## Paewira Application No APP143988 Additional Information

*[This revision dated 27 Sept 2023 corrects transcription errors in Table 1 and notes a typographical error in Table 3-2 of the original application document]*

The following information is in response to items listed in the Waikato Regional Council Notification Decision document dated 3/12/2021 that suggests that further information would be useful in assessing the application APP143988 by Global Contracting Solutions (GCS) for consent to discharge to air.

Figure 1. 99.9%ile SO<sub>2</sub> levels variation with flue gas exit temperature. Background levels and Fonterra discharges are not included

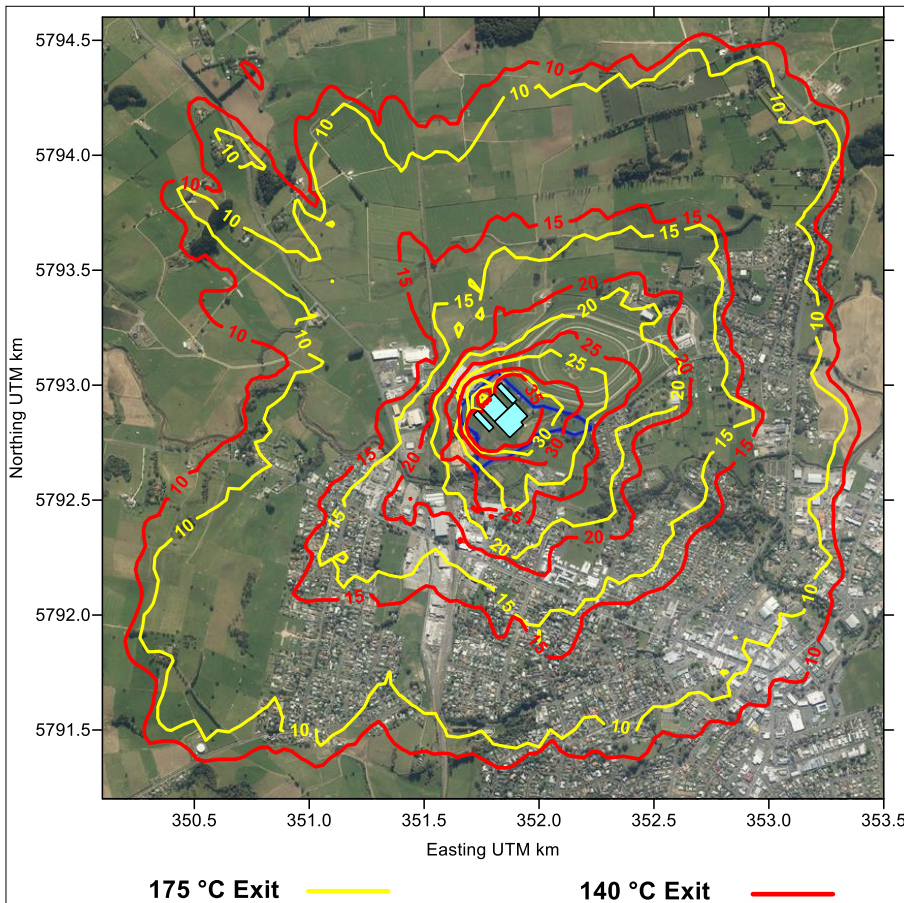
*Discharge temp of 175 °C is quite high compared to our experiences in Victoria (where 140 °C is typical) and implies incomplete heat recovery which could end up different in the final design. Modelling should consider sensitivity to discharge temp as this affects the plume buoyancy.*

While the flue gas temperatures are never expected to be as low as 140 °C for the Paewira plant, as suggested by the council's reviewer, as there is no low grade heat recovery, the effect of a 140 °C flue gas discharge is shown in Figure 1 for SO<sub>2</sub> and only small differences to the predicted 1-hour off-site levels are expected.

The plots in Figure 1 should be regarded as purely of academic interest only as a lower temperature from heat recovery is not being proposed.

**Figure 2.** 99.9%ile SO<sub>2</sub> levels variation with stack height for 38m and 50m high stacks. Background levels and Fonterra contributions are not included

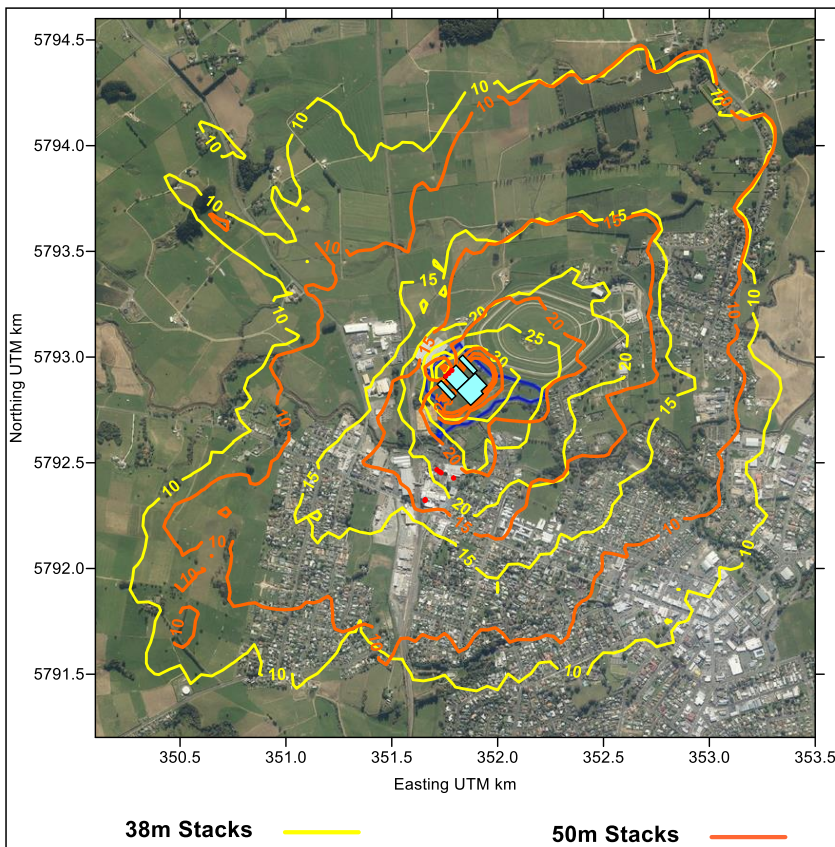
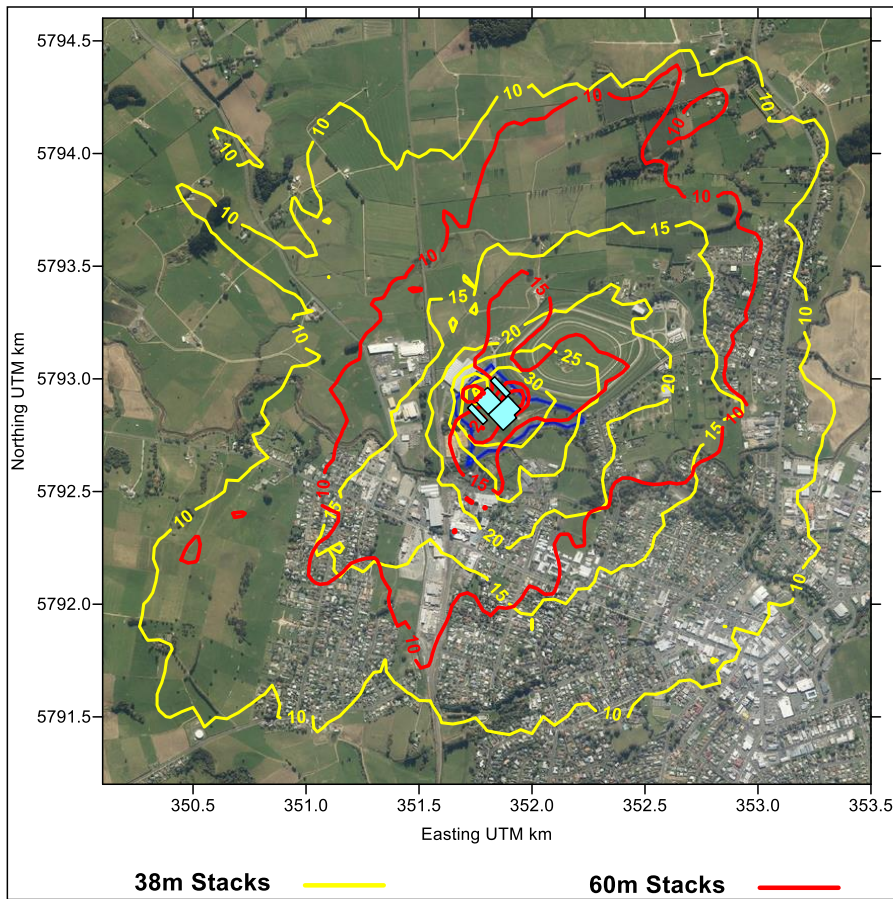
Given all the above, taller stacks may be needed. There is no serious consideration of this and this should be included in a “consideration of alternatives”. There is a small amount of discussion on this in the S92 response, but it needs more detailed assessment.

The 99.9%ile 1-hour predicted SO<sub>2</sub> levels for 38m, 50m and 60m high stacks are shown in Figures 2 & 3.

There is an incremental reduction in ground level concentrations very close to the plant for the increased stack height going from 38m to 50m stacks, but the differences at greater distances vary from moderate to negligible. The greatest reduction amounts to about 20% for some locations immediately adjacent to the plant boundary for a 50m height compared to the proposed 38m, but for other locations that are also on the boundary, there is no significant change e.g. the SW boundary. There is also no change for some locations 600 to 1500m to the SW of the RDF plant and 500 to 1600m to the NW. While not shown, the effects for 55m stacks are similar to those of 50m.

For 60m high stacks there is a reduction in off site effects for some locations close to the RDF plant boundary but minimal change for more distant locations as for the 50m stack option.

Note also that these modest improvements apply only to short term 1-hour impacts that are only relevant to SO<sub>2</sub> and NO<sub>2</sub> which already comply with appropriate NZAAQS's for the 38m stacks and extended stacks of 50 to 60m high are not considered to be warranted.
